**NOTICE OF DECISION TAKEN BY THE LEADER OF THE COUNCIL – (LD05)  
COUNCIL'S RESPONSE TO ENGAGEMENT EXERCISE ON INLAND BORDER  
CONTROL FACILITY**

<b>Decision No:</b>	<b>LD05</b>
<b>Subject:</b>	<b>RESPONSE TO DEPARTMENT FOR TRANSPORT'S ENGAGEMENT EXERCISE ON PROPOSALS TO ESTABLISH AN INLAND BORDER CONTROL FACILITY AT WHITE CLIFFS BUSINESS PARK</b>
<b>Notification Date:</b>	<b>11 February 2021</b>
<b>Implementation Date:</b>	<b>10 February 2021</b>
<b>Decision taken by:</b>	<b>Councillor Trevor Bartlett, Leader of the Council</b>
<b>Authority:</b>	<b>By virtue of Section 9(E) (2) (a) of the Local Government Act 2000</b>
<b>Decision Type:</b>	<b>Executive Non-Key Decision</b>
<b>Call-In to Apply?</b>	<b>No (<i>The Chairman of the Council has agreed to suspend call-in for the reasons set out in paragraph 3.2</i>)</b>
<b>Classification:</b>	<b>Unrestricted</b>
<b>Reason for the Decision:</b>	To respond to the engagement process in relation to the Government's proposal to construct an Inland Border Facility (IBF) on a 37.6 hectare site at the White Cliffs Business Park, Dover.

**PROPOSED RESPONSE TO THE ENGAGEMENT EXERCISE BEING UNDERTAKEN BY THE DEPARTMENT FOR TRANSPORT ON PROPOSALS

**Figure 1: White Cliffs Business Park - Allocation**

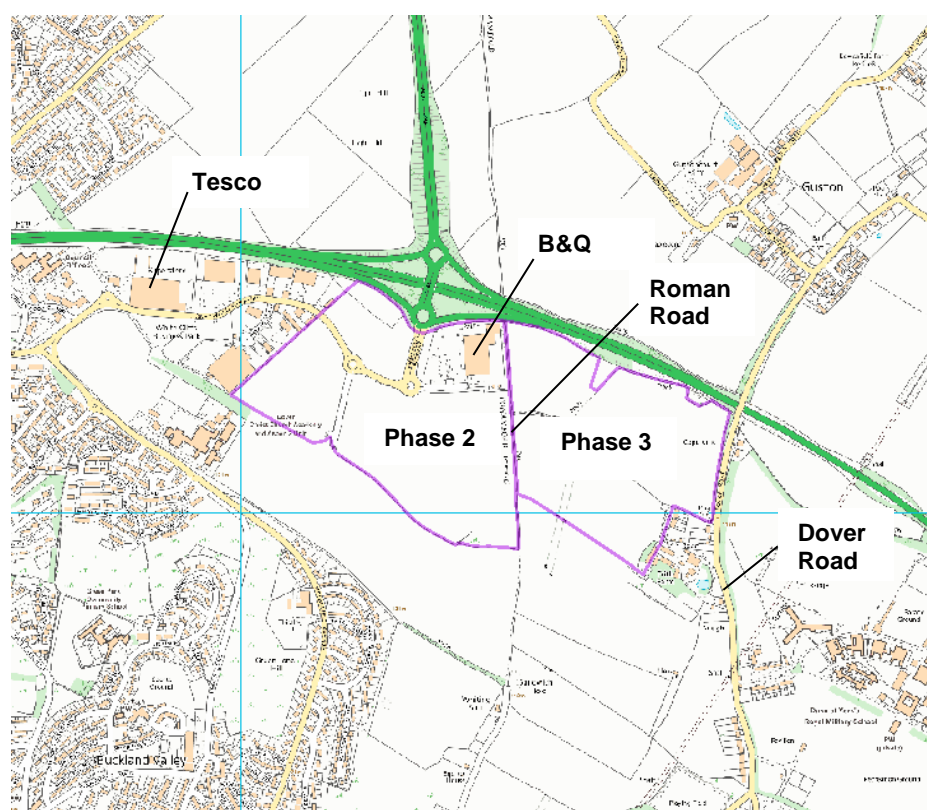
Policy LA2 identifies land for employment development at White Cliffs Business Park, referred to as Phase 2 and Phase 3, as shown at **Figure 1**. Phase 2 comprises the eastern end of Honeywood Parkway, where recent development including the B&Q store, Dover Leisure Centre and Lidl are located, as well as yet undeveloped agricultural land. Phase 3 consists of land to the east of Roman Road, up to Dover Road / St Martin’s Road.

The supportive text of Policy LA2 makes reference to the adjacent houses on Dover Road / St Martin’s Road, requiring at least a 25m wide landscape buffer with earth bunds and dense planting to be provided, as well as limiting the type of business / industrial activity closest to those houses to that compatible with their residential amenities.

**Figure 2: Site Location Plan**

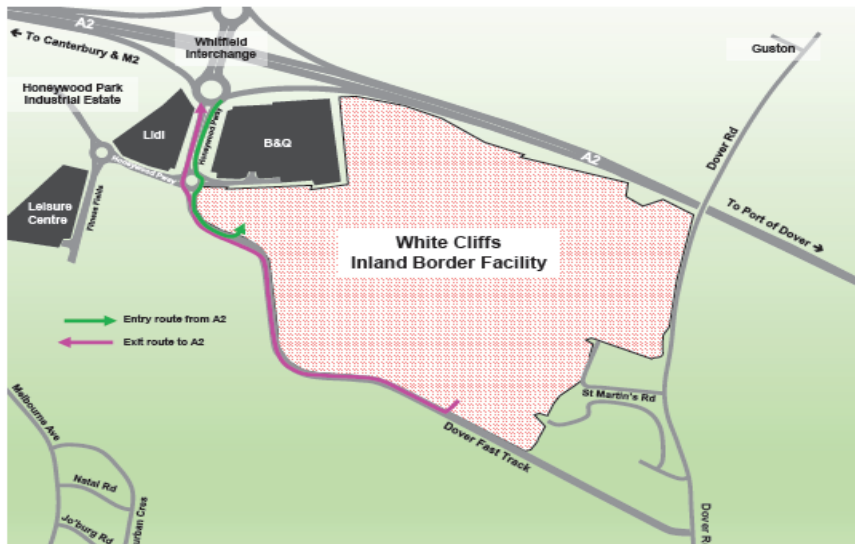
- 1.7 A Site location plan is at **Figure 2**; and an aerial photo of the Site and surrounding area is **Figure 3**.
